22 March 2024

Enquiries: Andrew Farran  
Project No: 301400273

**RE: Thornton Central Village  
Response to Submissions**

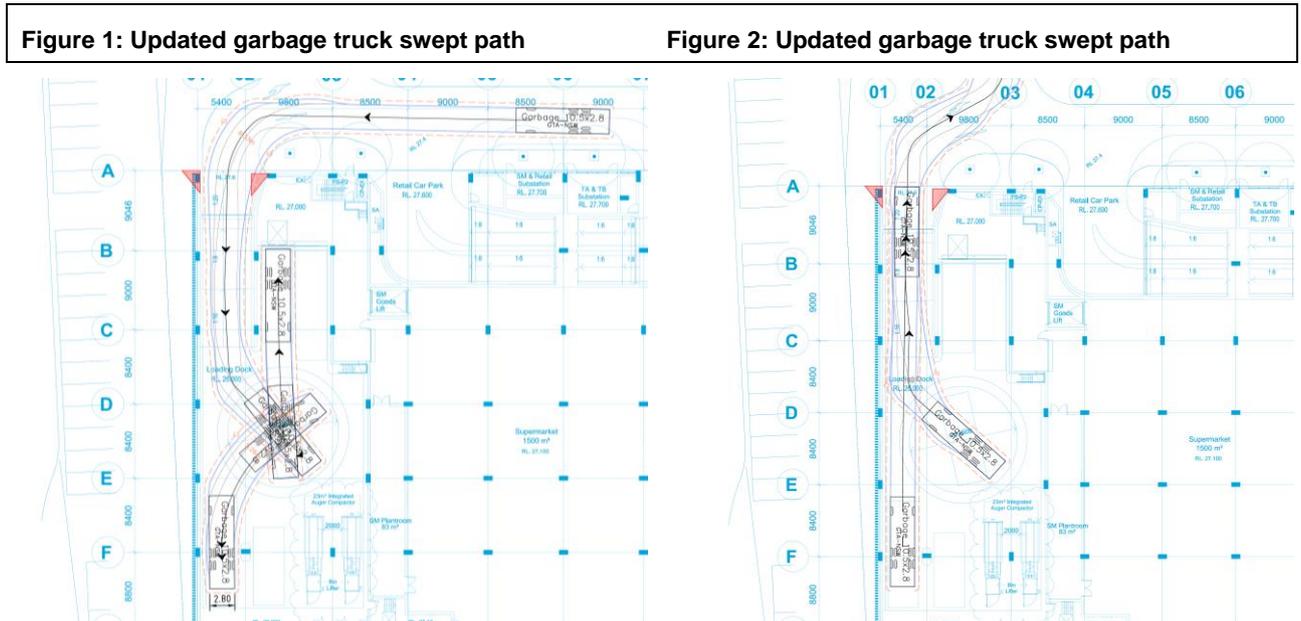
***A III: Concern is raised regarding potential heavy vehicle conflicts accessing the loading zone at the southern boundary of the site. The loading zone driveway only provides for access by one heavy vehicle, which creates a potential for excessive reverse manoeuvres or reversing onto the public road. The application must address potential heavy vehicular conflicts and consider the provision for the passing of two heavy vehicles along the driveway.***

In order to reduce the likelihood of conflicting vehicle movements occurring at the loading access it is recommended that a Loading Dock Management Plan (LDMP) be prepared prior to occupation as part of future Consent Conditions.

As detailed in the DA2 TIA, the expected number of loading deliveries is estimated at 25 per day across both loading docks (noting there would be minor increases to this, as noted in the response to DA2 RFI Comment C I). Regardless, given the low loading demand the likelihood of two vehicles entering/ exiting simultaneously is very unlikely. Notwithstanding, St Hilliers is also committed to implementing a dock management system to efficiently manage utilisation of all on-site loading spaces, requiring vehicles to be booked to controlled and defined timeslots ensuring a more equitable distribution of vehicles across the day rather than concentrated to shorter peaks. Such fundamental management measures are common for new mixed use developments across Sydney to ensure loading demand is appropriately managed with demand to not exceed loading supply at any given time. These systems would further reduce any likelihood of two vehicles simultaneously entering and exiting the loading docks.

Finally, it is noted that should a vehicle already be on the accessway when another vehicle arrives to enter from Dunshea Street, the entering vehicle would be required to prop and give-way to the exiting vehicle. This outcome is not dissimilar to a vehicle propping on the carriageway to reverse into a parallel car parking space. Moreover, at the loading access Dunshea Street is configured with a one-way traffic flow and carries low traffic volumes and as such, any delay to vehicles on Dunshea Street would be minor.

The proposed loading access arrangement, including the provision of a loading management plan, is considered acceptable.

**Figure 4: AS2890.2 sight distance requirements**

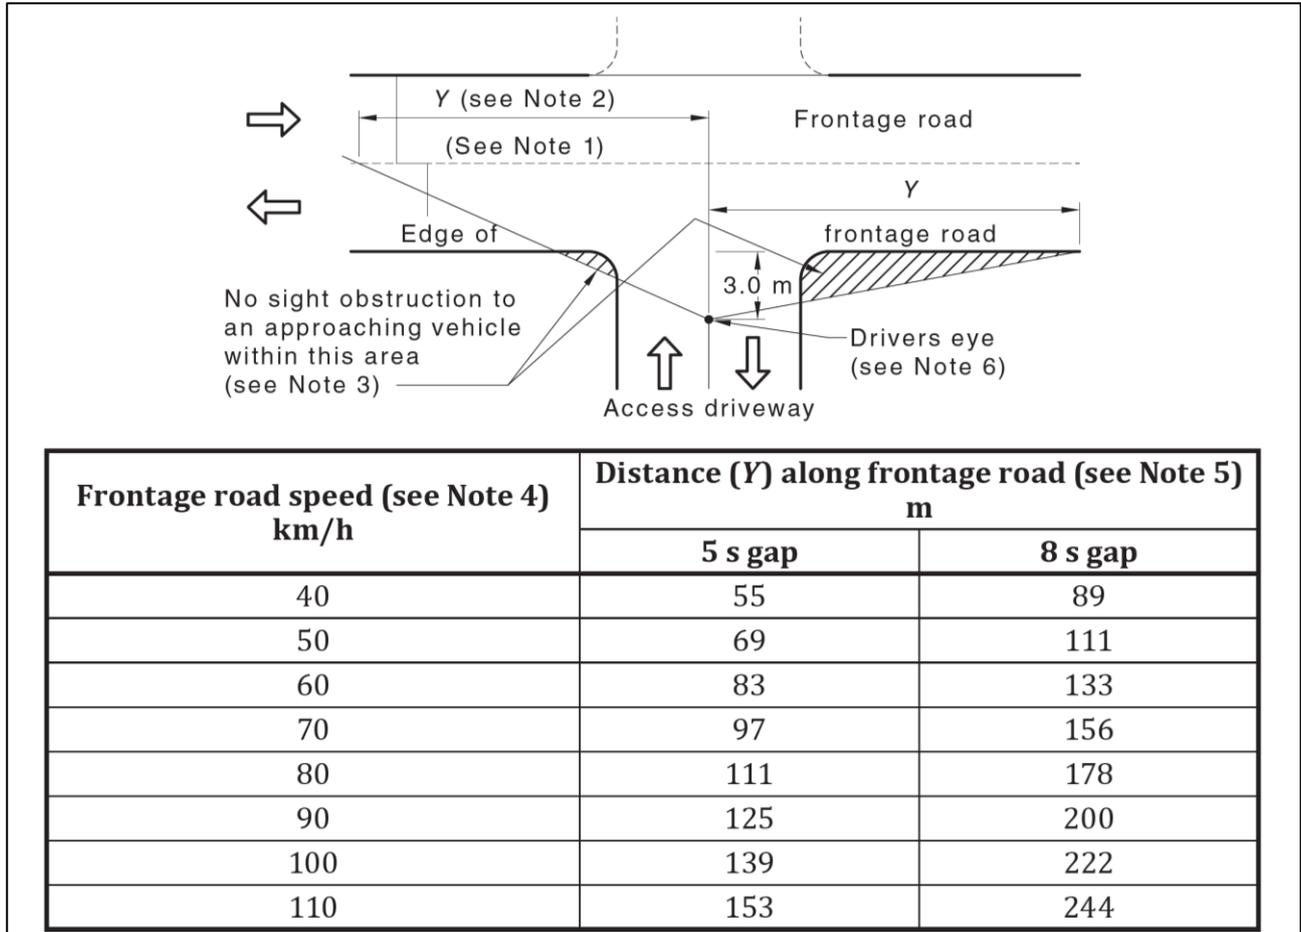
***E XV: The Applicant is also requested to demonstrate that the required sight lines at loading dock entry are provided in accordance with AS2890.2.***

The design review has been updated to include a sightline assessment for egressing vehicles from the Stage 1 loading dock entry. Figure 3.3 of Section 3.4.5 AS2890.2 details sight distance requirements for a commercial vehicle egressing an access driveway, and has been reproduced in Figure 4.

With an imposed speed limit of 50km/h on Dunshea Street egressing vehicles are required a sight distance of 69m (based on a 5 second gap) – the reality is that vehicles approaching the loading access would be travelling lower than 50km/h as they are approaching a 90 degree bend in the road. The sightline assessment, shown in Figure 5, indicates that this is comfortably achieved at the Stage 1 loading dock access and therefore is in compliance with Section 3.4.5 of AS2890.2.

**Figure 6: Development volumes - AM peak**

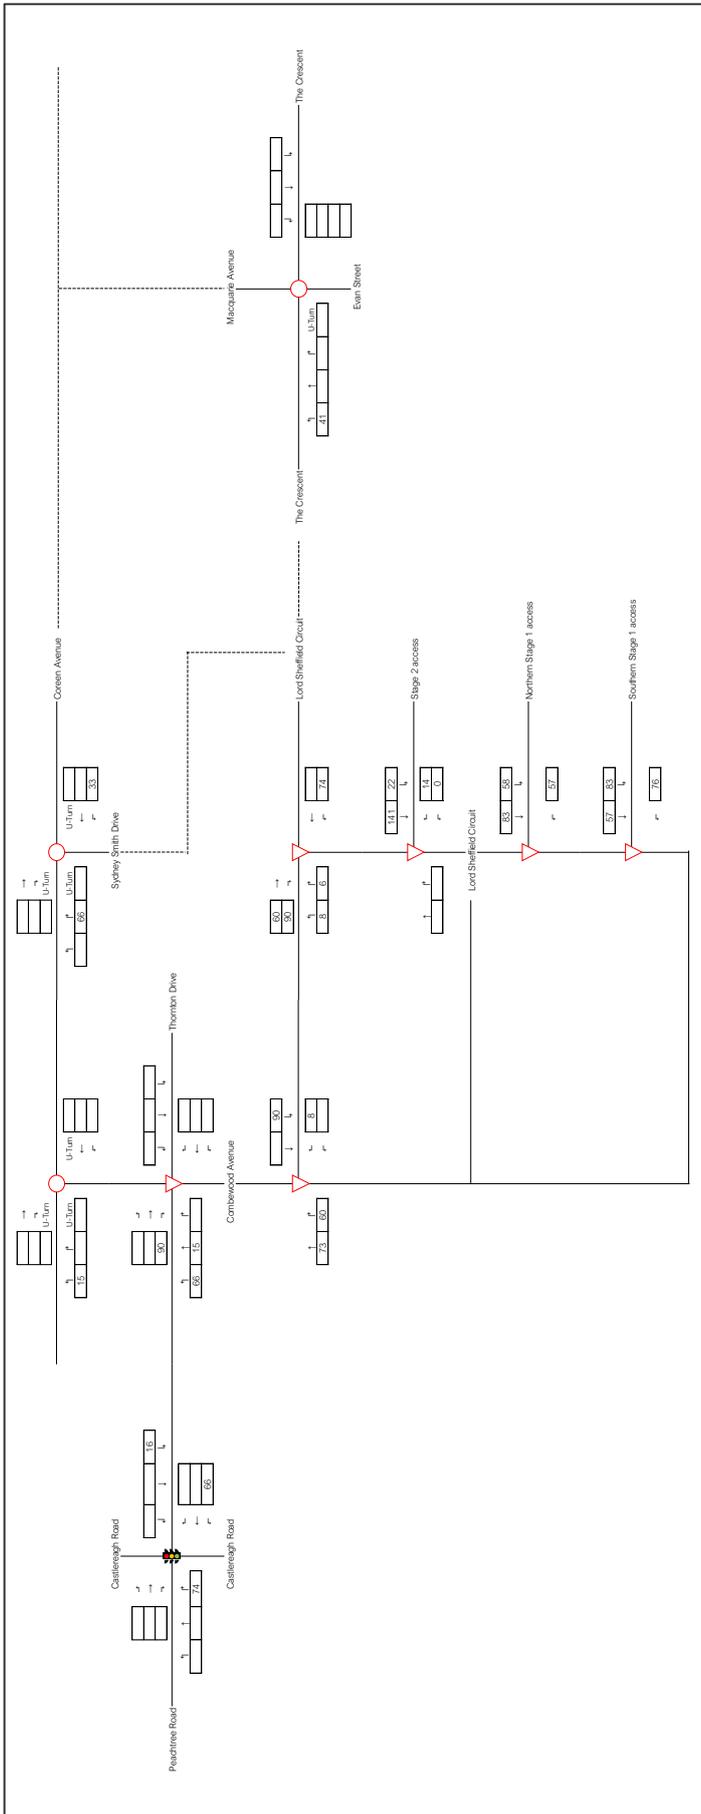
***E XIX: The assumed traffic distribution in Figure 7.1 requires further explanation, specifically to detail and show how traffic is distributed at each intersection. The traffic report shall also include traffic network diagram showing existing and future peak hour volumes for assessment.***

Traffic distribution diagrams for the development traffic are presented in Figure 6 and Figure 7 for the AM and PM peak hour, respectively. Regarding local access to the site the following is noted:

- Stage 2 access refers to above ground parking contained within Stage 2.
- Northern Stage 1 access refers to retail basement parking contained within Stage 1 as well as residential basement parking contained within Stage 2 (considering access to this parking area is via the Stage 1 basement).
- Southern Stage 1 access refers to above ground parking contained within Stage 1.

Swept Path Assessment

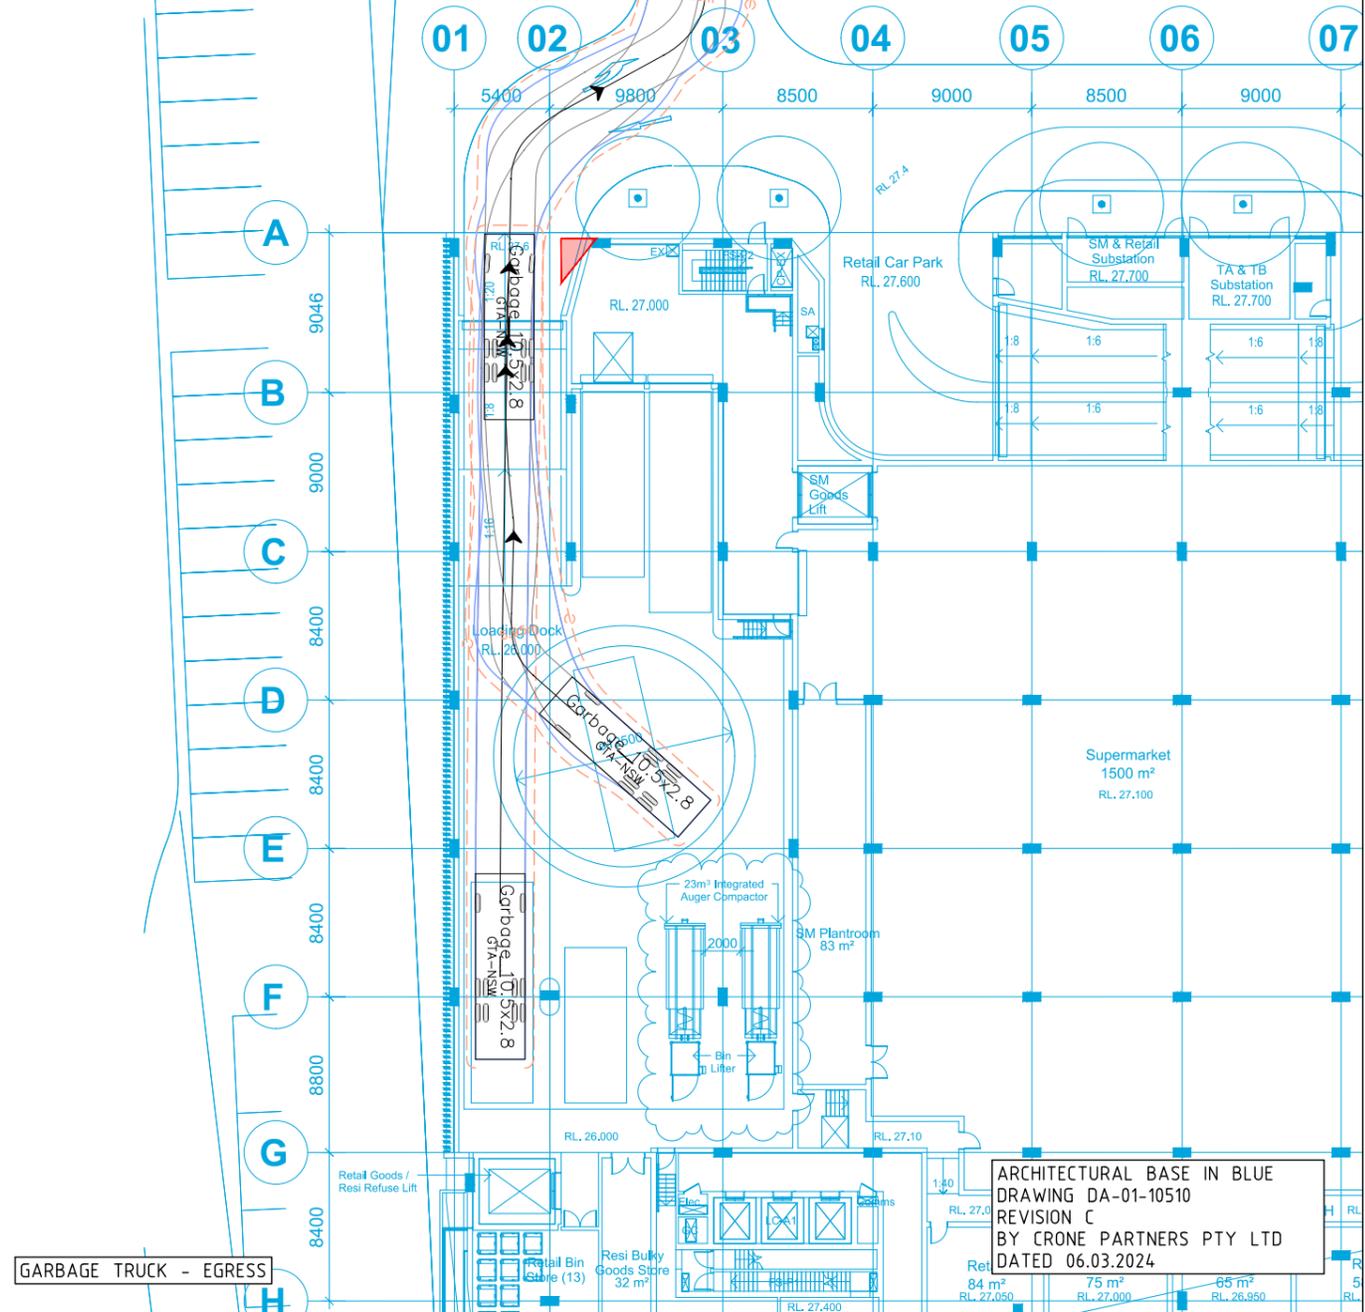
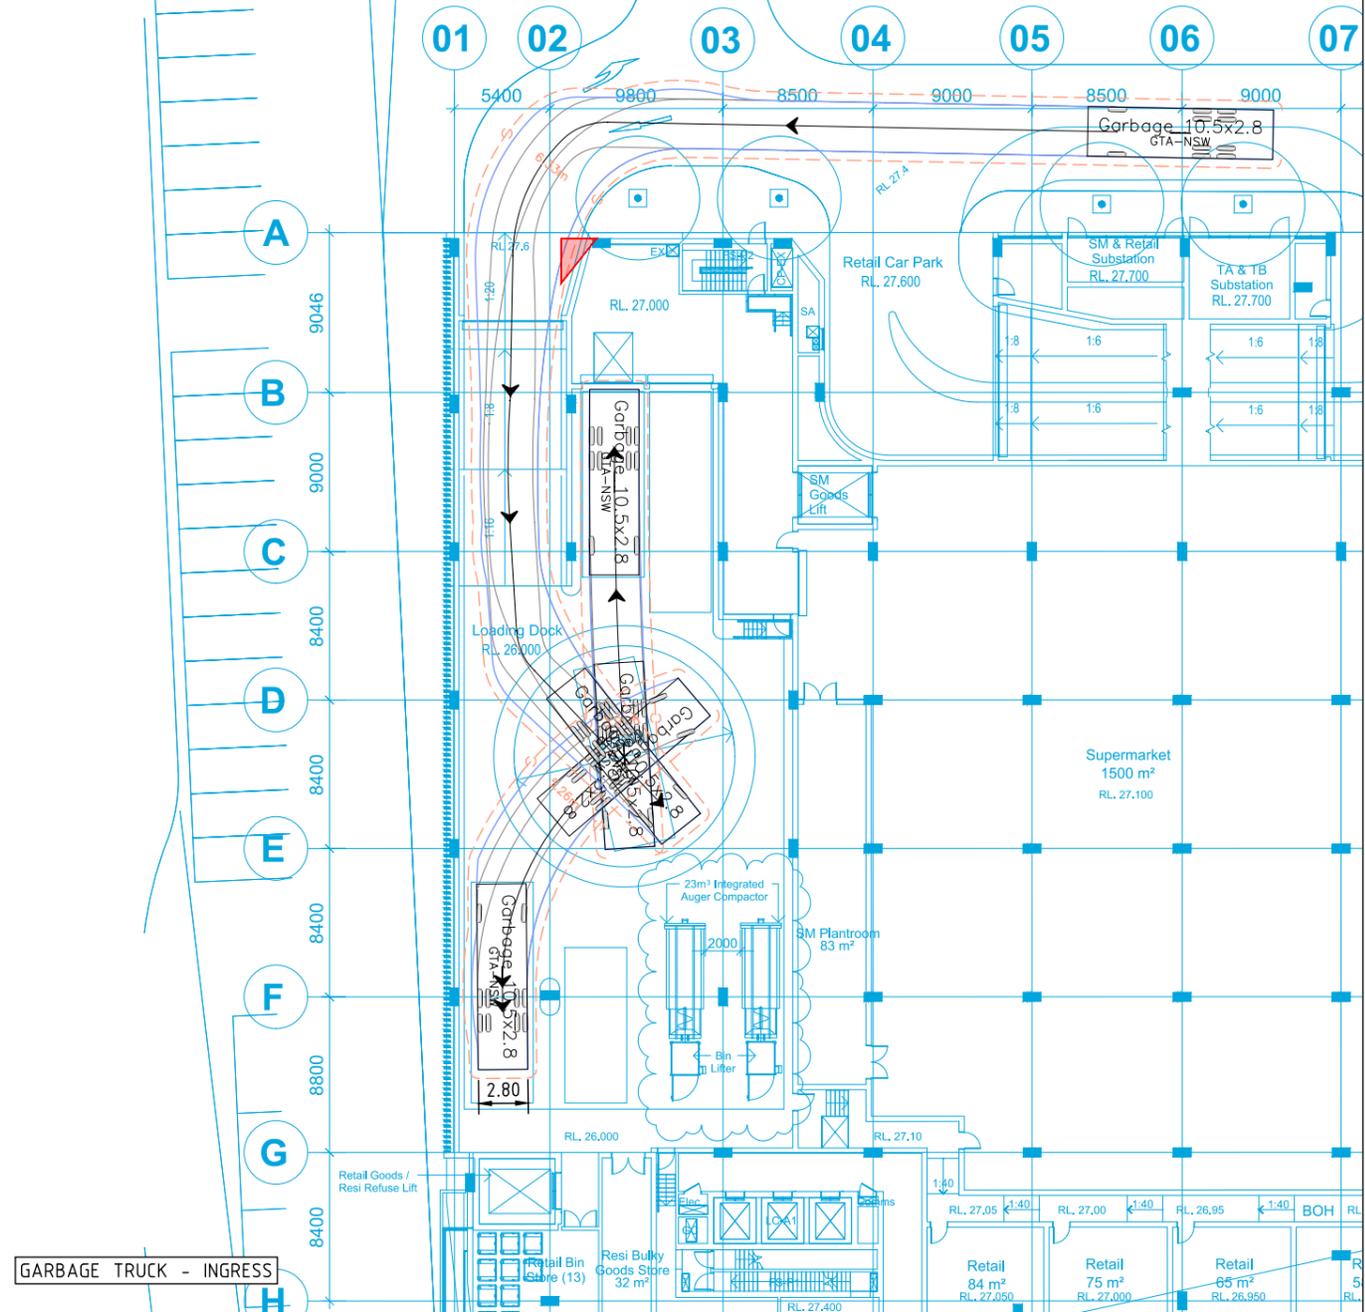
**D I: Appendix A Swept Path Assessment of the Transport Impact Assessment Report Issue #C shows the swept path diagram for the waste collection vehicles. A truck width of 2.8m and additional clearance of 0.5m on either side of the truck to be included in the swept path. In addition, the integrated auger compactor rails to be included on the plan to allow for the swept path diagram to demonstrate the truck aligning with the integrated auger compaction unit guide rails for removal and replacement of the unit.**

This comment is acknowledged, and the swept path assessment has been updated to include a 2.8m-wide garbage truck with clearances of 0.5m on either side. This swept path assessment is provided at Attachment 1 and reproduced in Figure 1 and Figure 2 depicting ingress and egress movements, respectively. The assessment confirms the loading dock can adequately cater for the wider garbage truck.
